# American Geotechnical, Inc.

April 2, 2021

Subject: **RESPONSE TO CITY OF LAGUNA NIGUEL GEOTECHNICAL REVIEW SHEET DATED FEBRUARY 15, 2021 AND NOTICE OF INCOMPLETENESS DATED FEBRUARY 23, 2021**  
Tentative Tract No. 17721  
The Cove at El Niguel  
30667 Crown Valley Parkway  
Laguna Niguel, California

References: **NOTICE OF INCOMPLETENESS FOR SITE DEVELOPMENT PERMIT SP 16-04 AND TENTATIVE TRACT MAP 17721 (30667 CROWN VALLEY PARKWAY – THE COVE AT EL NIGUEL)**  
By: Community Development Department, City of Laguna Niguel  
Dated: February 23, 2021

### 33348-08 The Cove at El Niguel Section J-J' 15.5' High MSE Wall\_Static

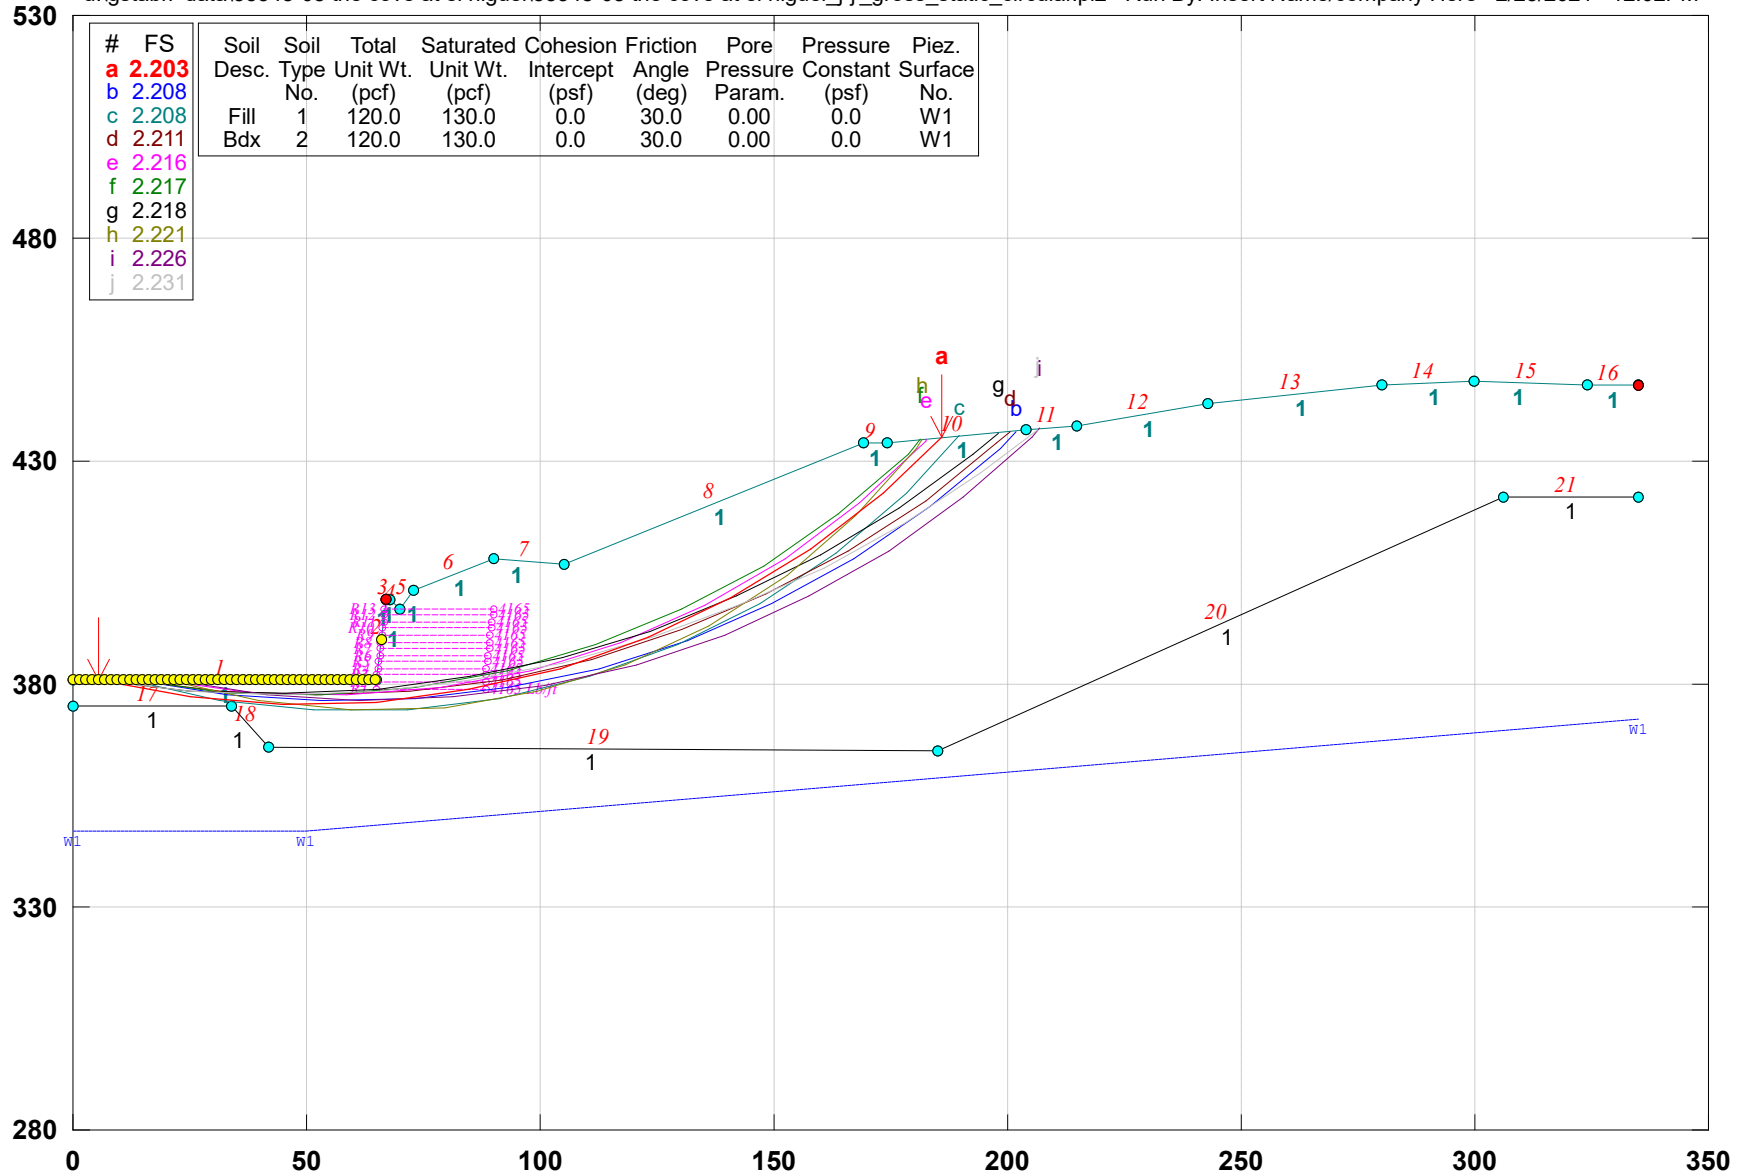
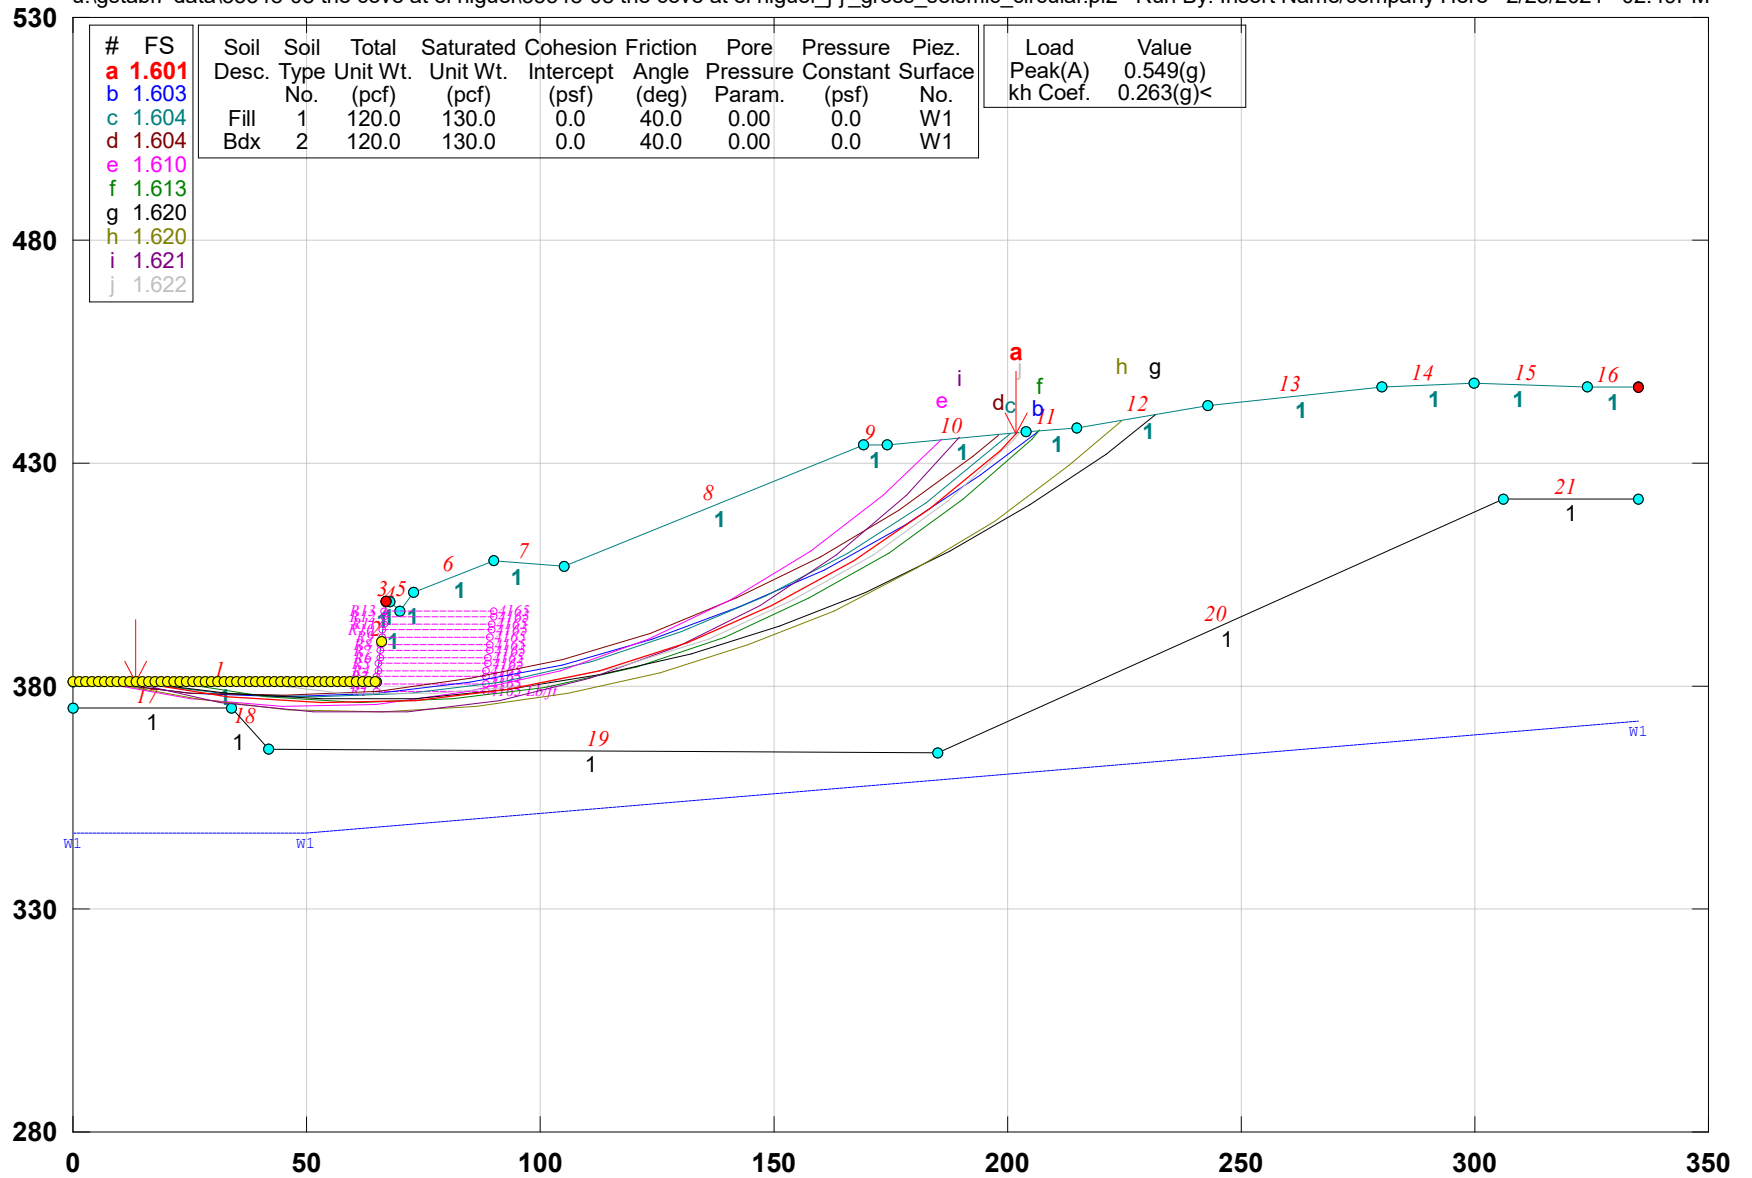
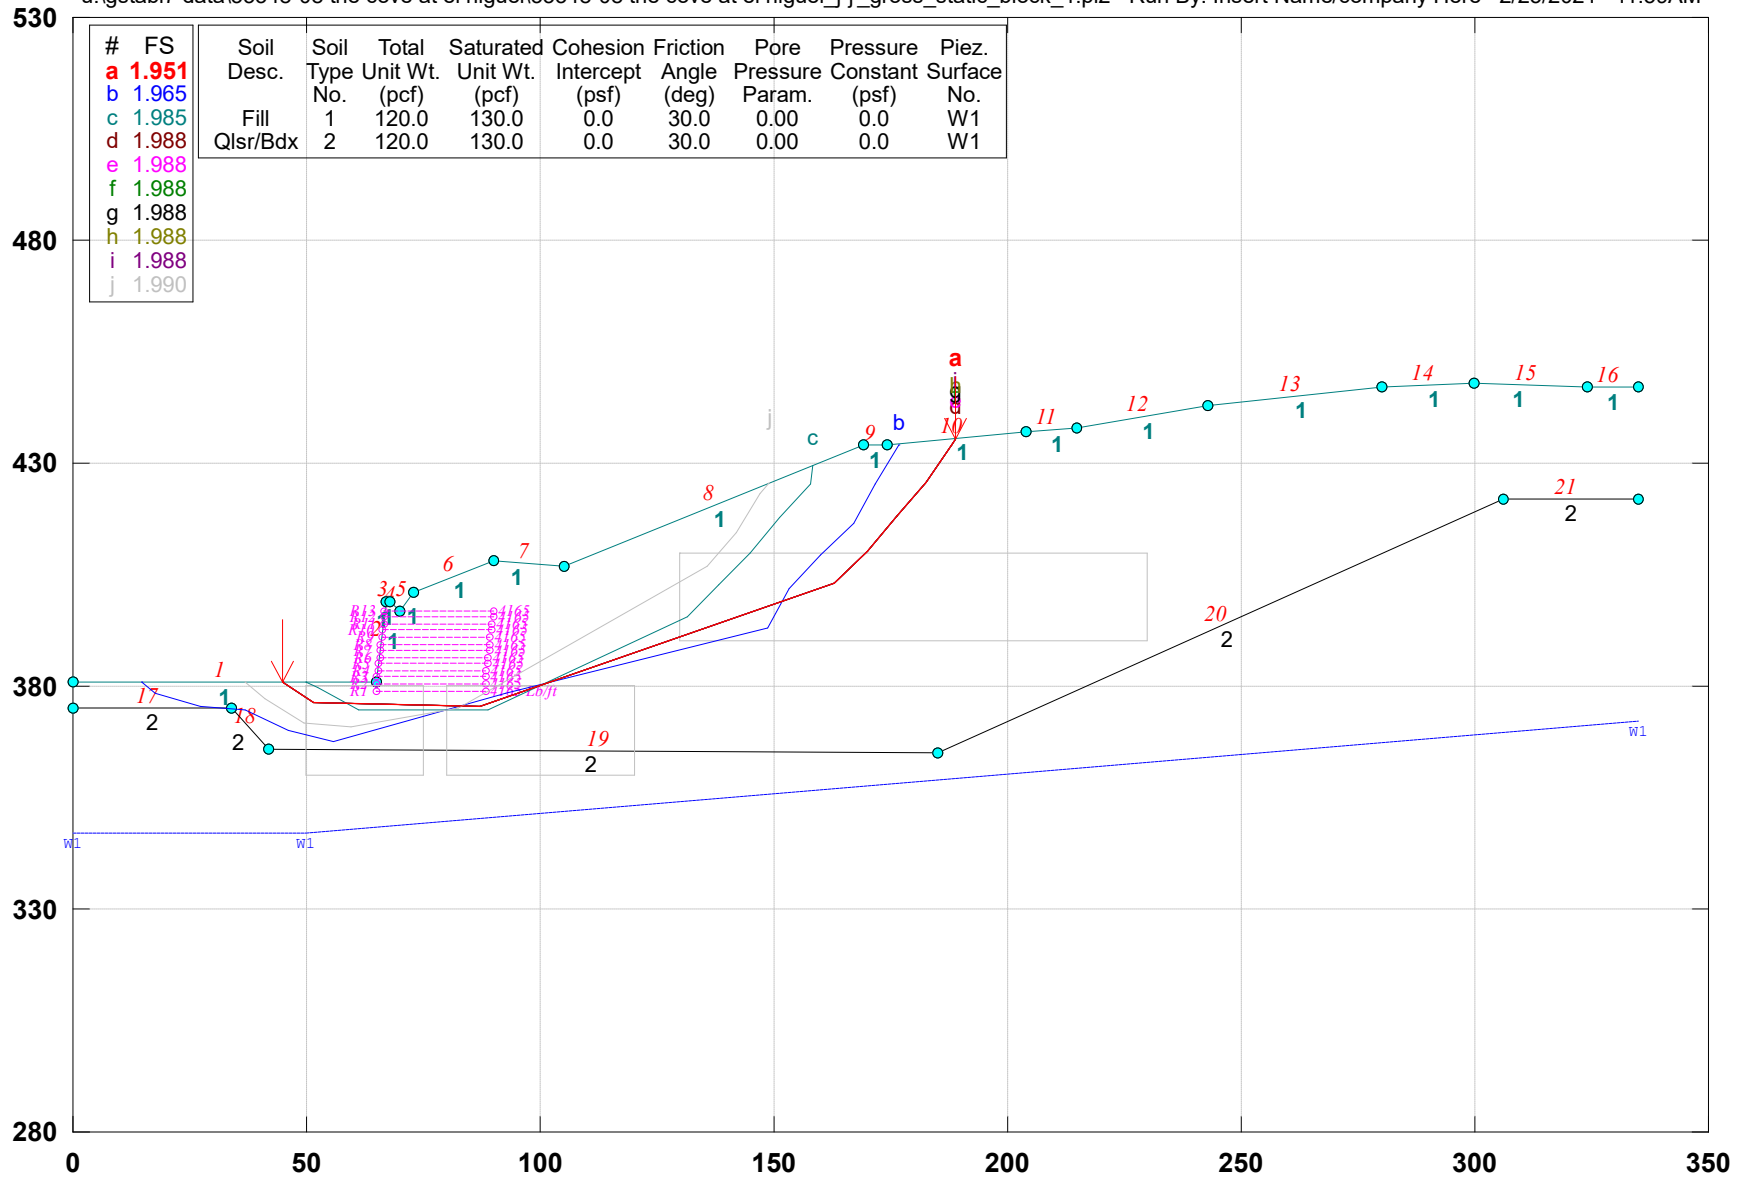
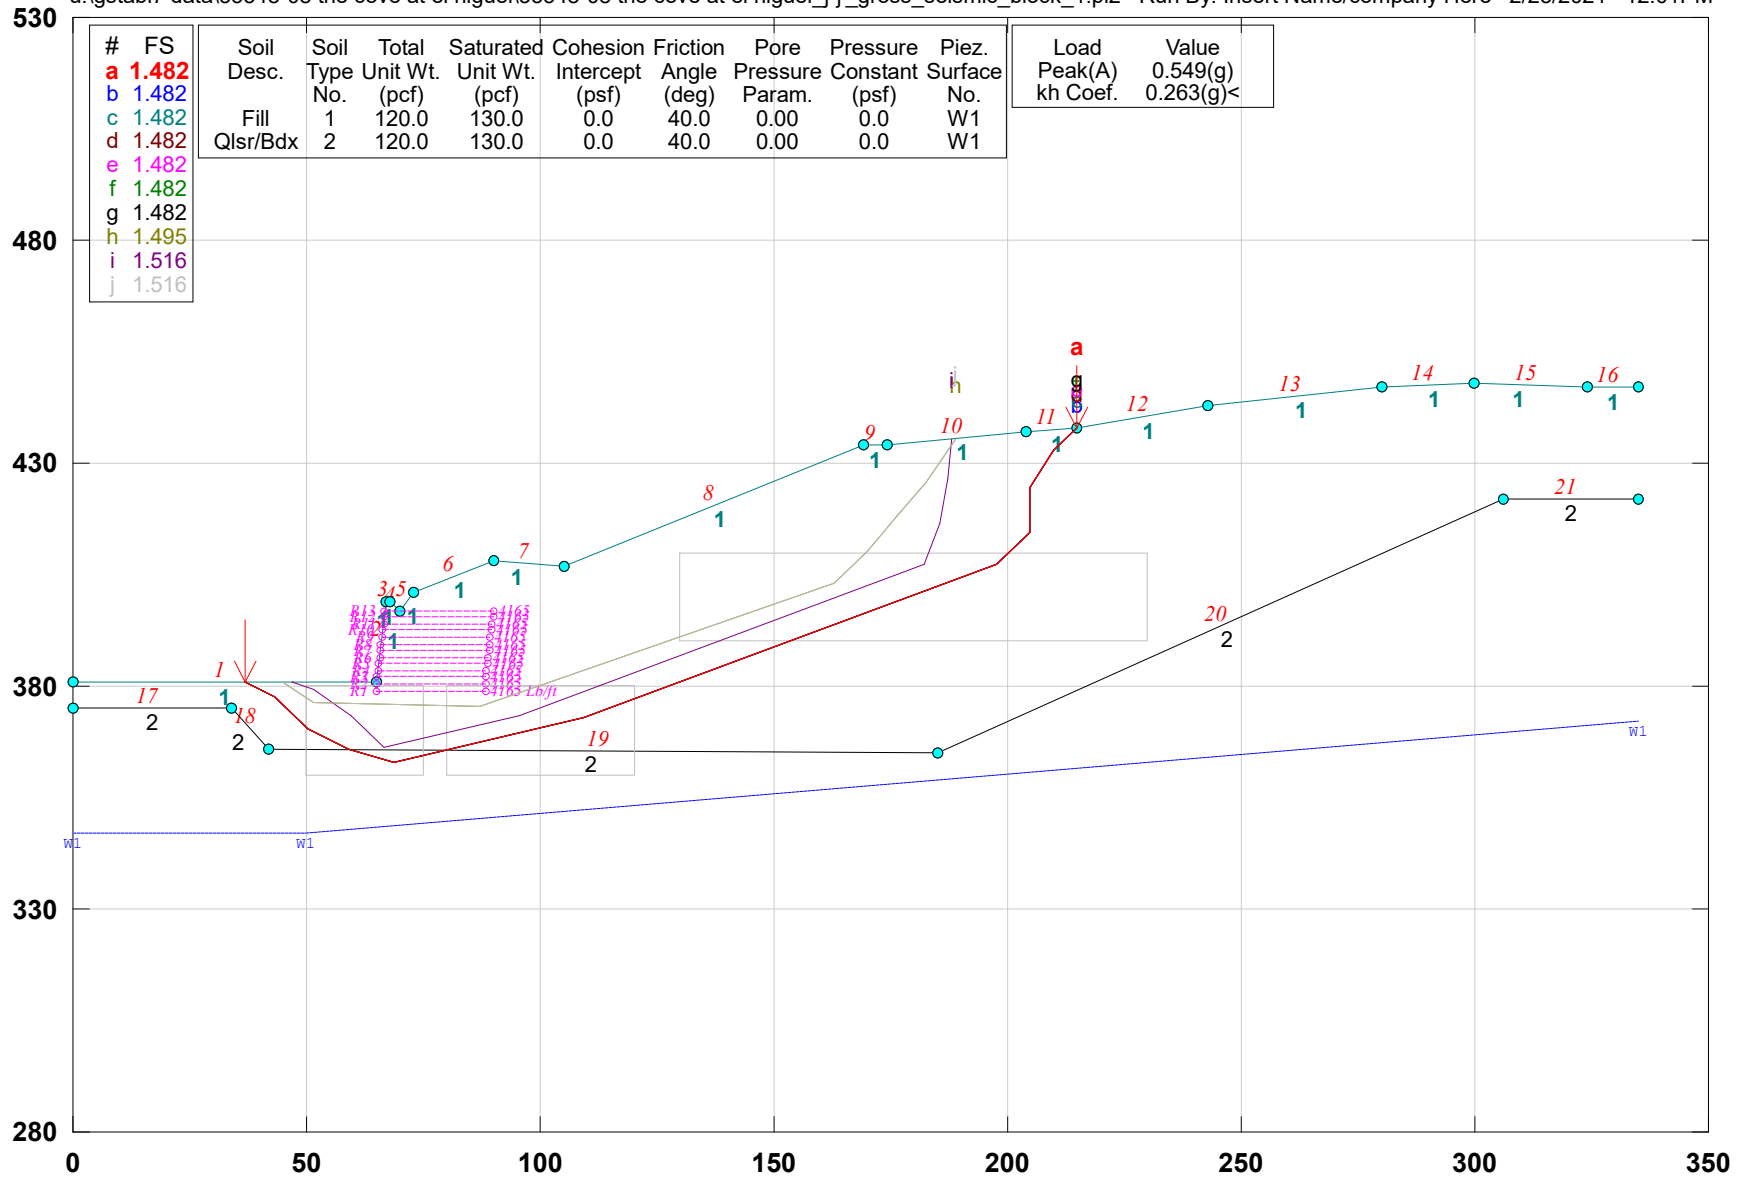
*Since the currently planned grading will now include the partial removal of the toe and keyway of the lower buttress, provide both static and seismic stability calculations for failure planes that extend from the new*

toe of the slope, below the MSE wall and through the slope above. Both circular and block type failure planes should be searched for Sections DR-DR' and J-J'.

Per the City's geotechnical review comments, we performed a supplemental stability analysis using block failure search extending from the new toe of the slope, below the MSE wall, and through the slope above. Results of our stability analysis using the block failure search for Section DR-DR' revealed that factors-of-safety under static (long-term) and pseudostatic/seismic (short-term) conditions are 1.823 and 1.267, respectively. Both values are exceeding the minimum required factors-of-safety of 1.5 and 1.1, respectively. Additionally, per the City's geotechnical review comments, we performed supplemental stability analyses for Section J-J' using both circular and block failure searches below the MSE wall and through the slope above. Results of our stability analyses revealed that the factors-of-safety under static (long-term) and pseudostatic/seismic (short-term) conditions are 2.203 and 1.601, respectively. Both values exceed the minimum required factors-of-safety of 1.5 and 1.1, respectively. Results of our supplemental stability analyses discussed above are included in **Appendix B**.

# 33348-08 The Cove at El Niguel Section J-J' 15.5' High MSE Wall\_Temp BC

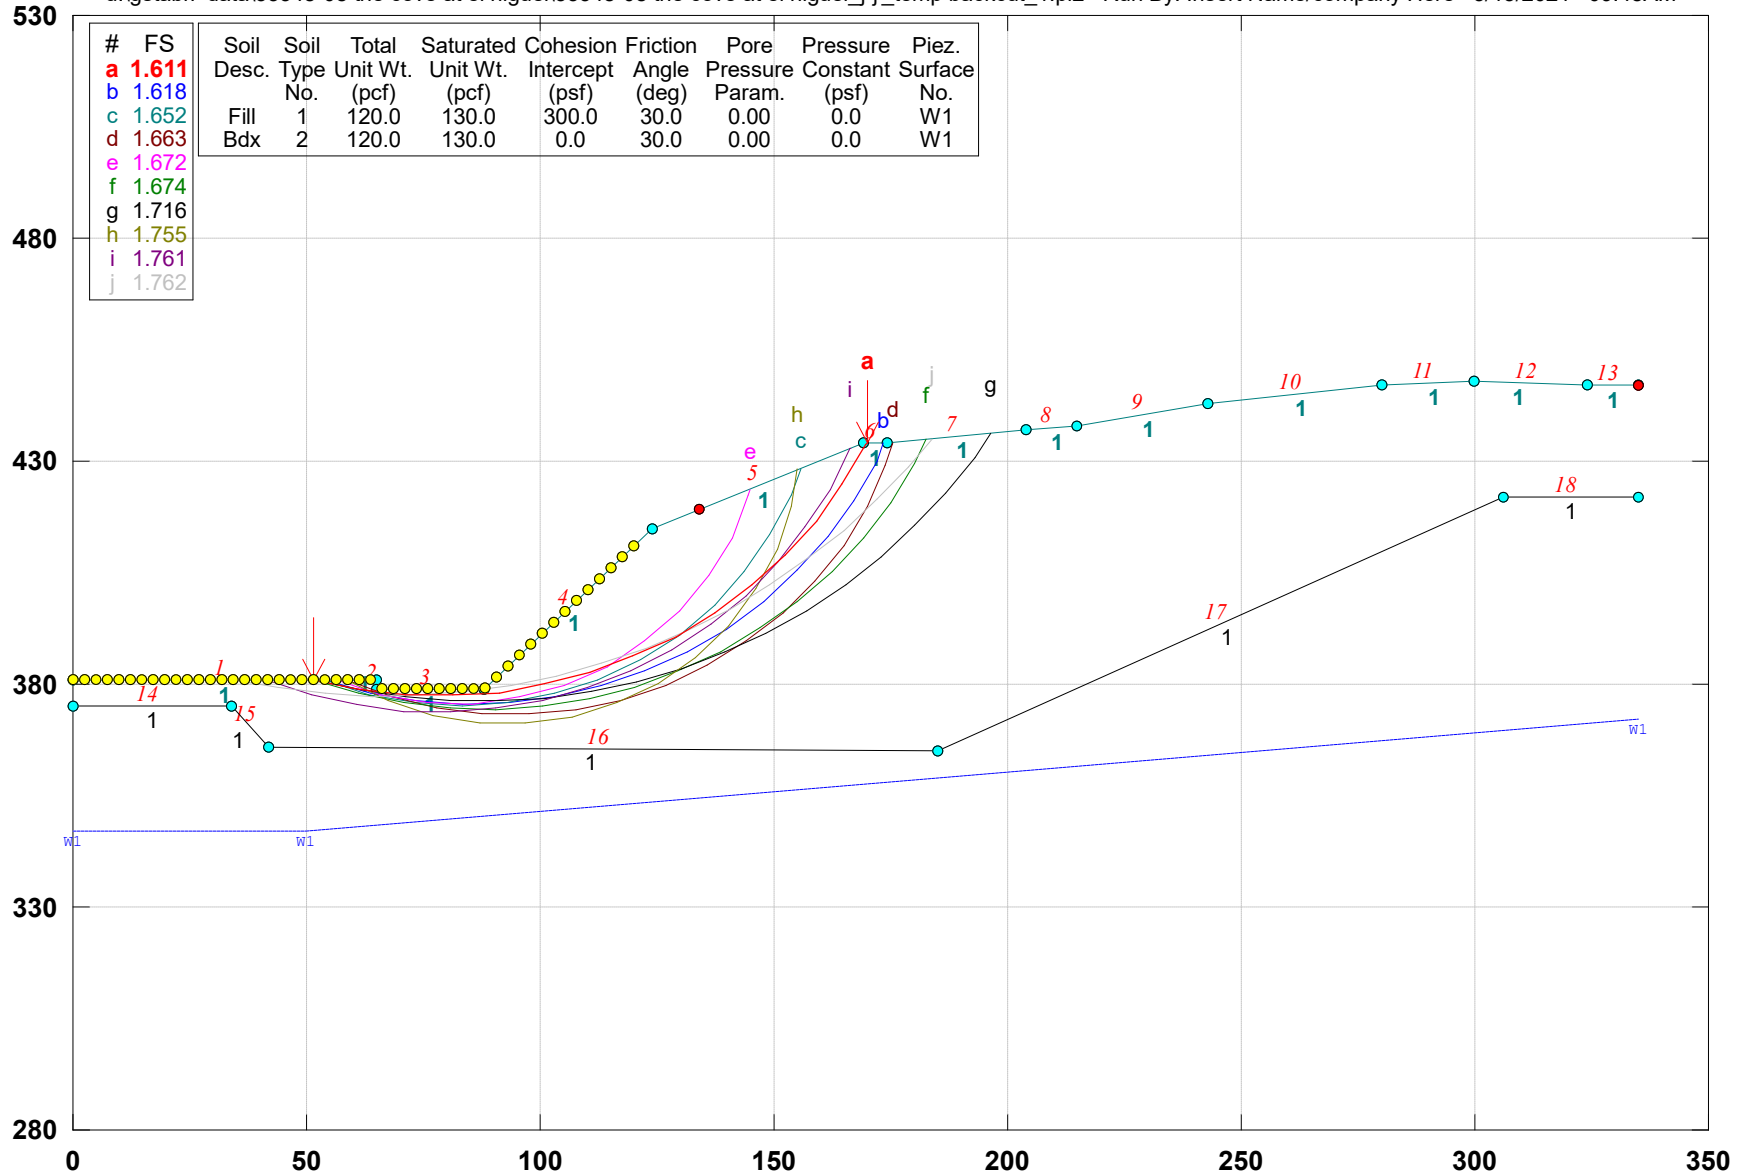
*The report states that stability calculations were performed for the temporary backcut that will be required to create the toe-of-slope MSE wall; however, the calculations and a summary of the results were not provided. Please provide.*

Temporary cuts in compacted clayey fill like that at the site have demonstrated very good temporary stability provided cuts are not surcharged. We propose that these temporary slopes be excavated no steeper than 1:1 (horizontal:vertical). Any specific proposal by a contractor for a steeper excavation should be subject to specific evaluation. Nonetheless, a temporary backcut stability analysis was performed on Cross-Section J-J' to evaluate the temporary backcut condition for construction of the proposed MSE wall up to a maximum of 15.5 feet in height. A minimum 23-foot wide key and 1:1 (horizontal:vertical) backcut slope was analyzed. For short-term temporary back cut excavation stability analysis, a cohesion of 300 pounds per square (psf) and 30 degrees of friction angle were used for fill material. These values were selected for use in the temporary backcut stability analysis to account for partially saturated conditions during temporary backcut excavation. These values, based on experience, are viewed as greatly conservative. Commonly, friction values of about 45 to 70 degrees are applicable to the low confining pressure ranges applicable to back-cut analyses.

Results of our temporary backcut stability analysis on Cross-Section J-J' revealed the factors-of-safety being 1.611 which is greater than the minimum required factor-of-safety of 1.25. Results of our temporary backcut stability analysis is presented in **Appendix B**.
